SUPPLEMENTAL SPECIFICATIONS

1988 English Standard Specifications for Highways and
Bridges

1995 Metric Standard Specifications for Highways and
Bridges

JULY 1, 2015

FIGURE 1

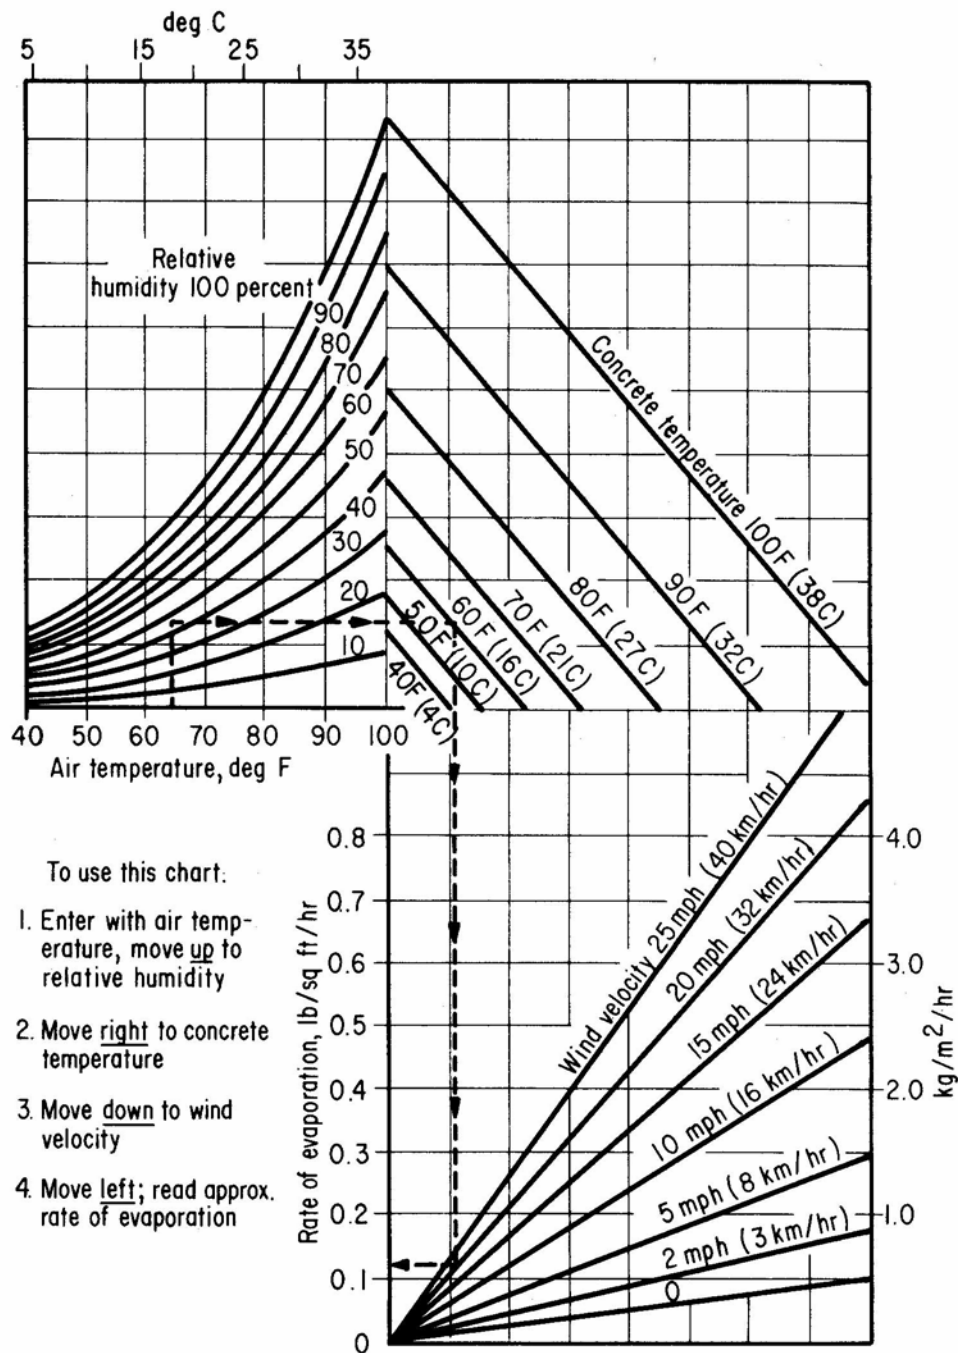
The weight of the finishing machine(s) shall not cause unaccounted deflection of the bridge members or falsework. The machine shall travel on steel rails, pipe or other approved grade control, which shall be supported by vertical supports securely fastened in place at a maximum spacing of 2 feet (200 mm) to prevent any appreciable deflection between rail supports. Screed rail supports may be located inside or outside of the placement width. Prior to placing the concrete, screed rails shall be completely in place, and accurately set to insure finishing of the concrete deck surface to the elevations shown on the Plans. The supports for the rails, if embedded in the deck concrete, shall be of the type that can be removed without disturbing the concrete.

Screed rails shall be set entirely above the finished surface of the concrete and shall be supported in a manner approved by the Engineer. Where stud type shear connectors are available, welding to the studs will be permitted. Where no studs are available, other means of attaching the screed rail supports shall be provided. No welding will be permitted directly on stringer or girder flanges or cover plates in tension areas, nor in areas subject to stress reversal, for attaching either screed rail supports of any type. Any welding in compression areas shall be approved by the Engineer.

Screed rail supports set in the concrete shall be so designed that they may be removed to at least 2 inches (50 mm) below the surface of the concrete. Voids created by removal of the upper part of the screed rail supports shall be filled with mortar having the same proportions of sand and cement as that of the slab or wearing surface. The mortar shall contain an approved additive in sufficient proportions to produce non-shrink or slightly expansive characteristics. Screed rail supports shall not be treated with parting compound to facilitate their removal. Rails for finishing machines shall extend beyond both ends of the scheduled length for concrete placement. The extended length shall be of sufficient distance to allow finishing machine(s) to clear the concrete to be placed.
